Authorized Field Change

AFC 18903

Subject: Transmission Cooler Line Routing

Model: Certain International® HX® Series 620 model trucks.

Figure 1. Incorrect Transmission Cooler Line Installation

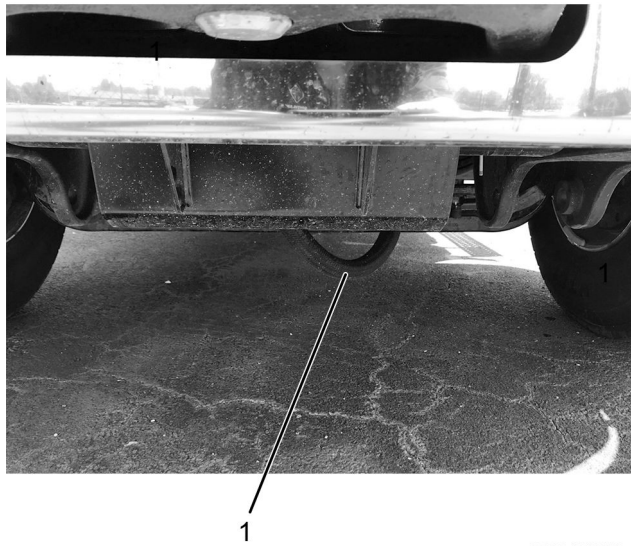
NOTE: The transmission cooler lines are different in length. If the transmission cooler lines were connected to the incorrect transmission and transmission cooler fitting, the transmission lines can hang down below the front skid plate.

Figure 2. Correct Transmission Cooler Line Routing

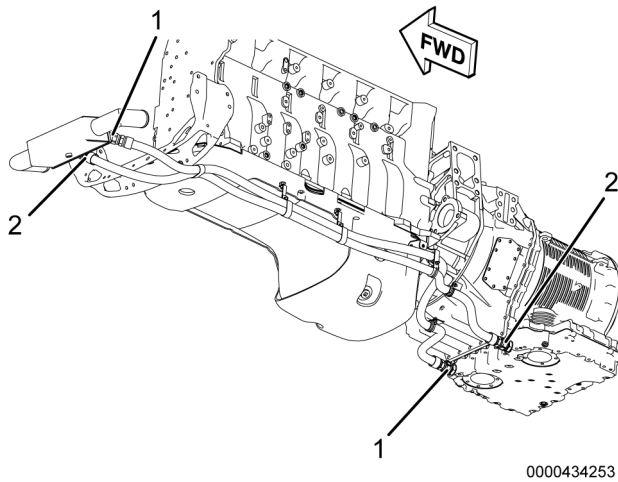
1. Hose from right trans fitting to left trans cooler fitting (longer hose)
2. Hose from left trans fitting to right trans cooler fitting (shorter hose)

7. Starting at transmission fittings:
 - a. Fitting on right-side at transmission should be connected to fitting on left-side of transmission cooler (Figure 2, Item 1).
 - b. Fitting on left-side at transmission should be connected to right-side of transmission cooler (Figure 2, Item 2).
8. Transmission cooler lines routing:
 - a. If cooler lines are routed correctly, proceed to Step 17.
 - b. If cooler lined are routed incorrectly, continue to Step 9.
9. Inspect hose for leaks.
 - a. If hose requires replacement, hose must be replaced before proceeding to next step.
 - b. If hose is not leaking, continue to next step.
10. Using clean pans, place pans under transmission and transmission cooler lines.
11. Loosen transmission cooler line cushion clamps along engine to allow hose to move freely.
12. Remove hoses at transmission cooler.

NOTE: The hose which connects right-side of transmission to left-side of oil cooler is longer.

13. Remove hoses at transmission and install hoses on opposite fitting at transmission.
14. Adjust and route transmission cooler lines to reach correct oil cooler fittings and install hoses.
15. Tighten all hoses and hose clamps.
